Sheet: /power/
File: power.kicad_sch

Sheet: /opamp_amp/
File: opamp_amp.kicad_sch

Sheet: /clock/
File: clock.kicad_sch

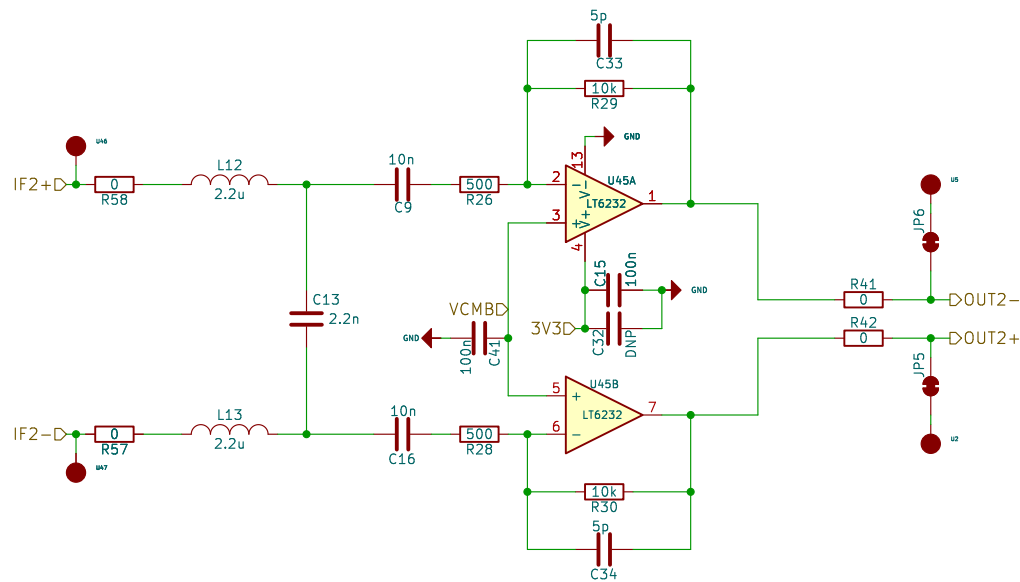
FPGA FIR Filter works perfectly.
Second stage for HPF
range compensation filter is removed

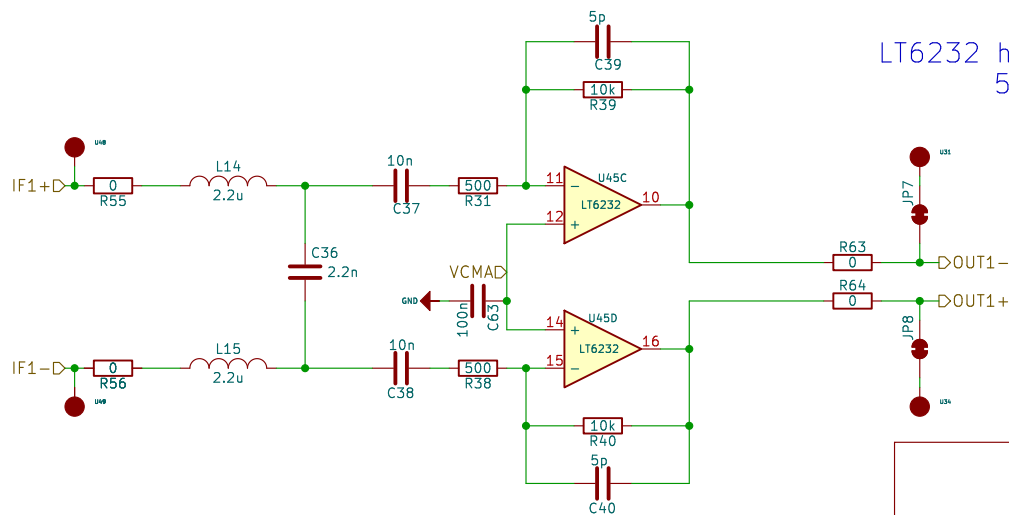
LT6232 has better noise performance as $1.1\text{nV}/\sqrt{\text{Hz}}$
500 10K has less noise contribution

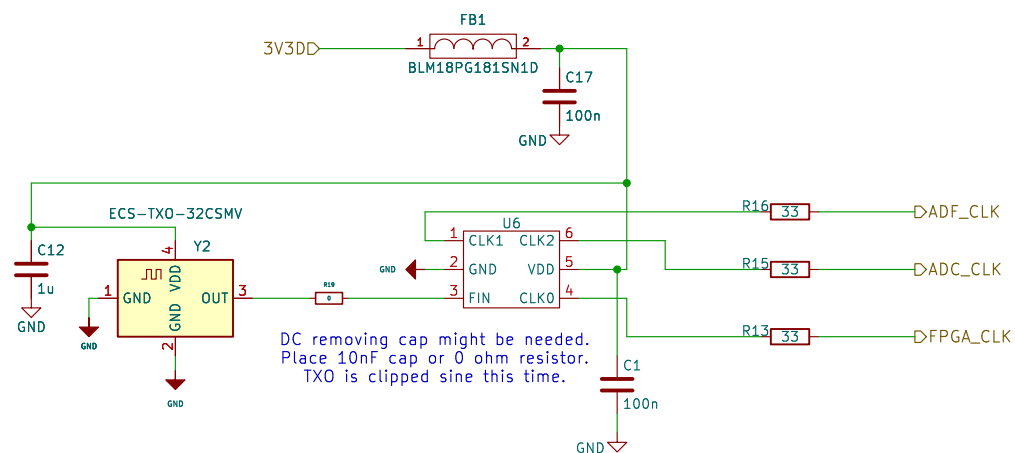
This is the prev design:
NB3N551 is obs.
Also this txo is generating pure sin.
ADC might need cmos like input not sin.
That could be the reason of duty stabilizer.

DC removing cap might be needed.
Place 10nF cap or 0 ohm resistor.
TXO is clipped sine this time.
